ELK RIVER ROWD – APPENDIX F

HRC Aquatic Trends Monitoring (ATM) Program Property-Wide and Specific to Elk River

September 22, 2014

Figure 2. Cumulative Frequency Plot and Histogram of Surface Particle Size at ATM Station 162 in Elk River for 2010, 2011, and 2013

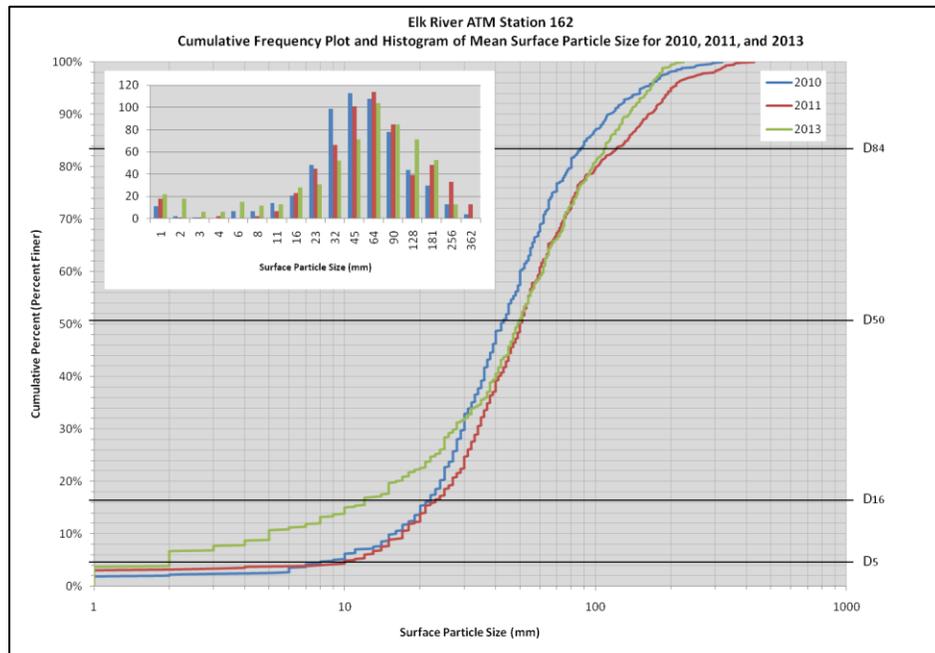
- 1) **Pebble Counts:** Continue to measure surface sediment through grid counts, measuring 200 pebbles at the each of the first 3 riffles spanning the bankfull channel width. Data analysis will be expanded to determine D₈₄, D₁₆ and D₅ as three new parameters measured and tracked, in addition to D₅₀. Results will be reported as mean values within the APFC matrix (Figure 1), as well as cumulative frequency plots, which serve to provide a visual aid for improved interpretation (Figure 2).

Figure 3. Results from a Full River LWD Survey (top) and an ATM LWD Survey (bottom) from Elk River.

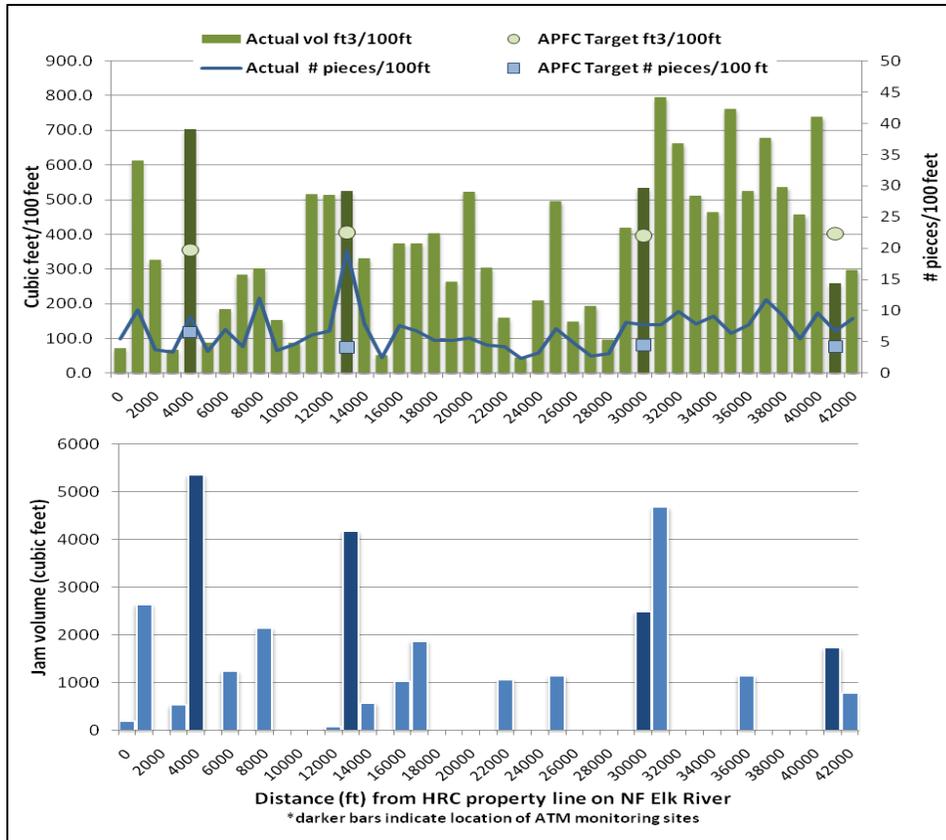
- 4) **LWD:** Discontinue measurements of diameter, length, volume, and key pieces except during extended river wood surveys to be conducted once every 6 years. Total piece frequency per 100ft would remain a monitored ATM station parameter providing a general sense of wood loading.

- c. A periodic extended river reach wood survey of the North Fork will provide a detailed measure of LWD characteristics and distribution which can then be compared to annual values collected during ATM surveys (Figure 3).
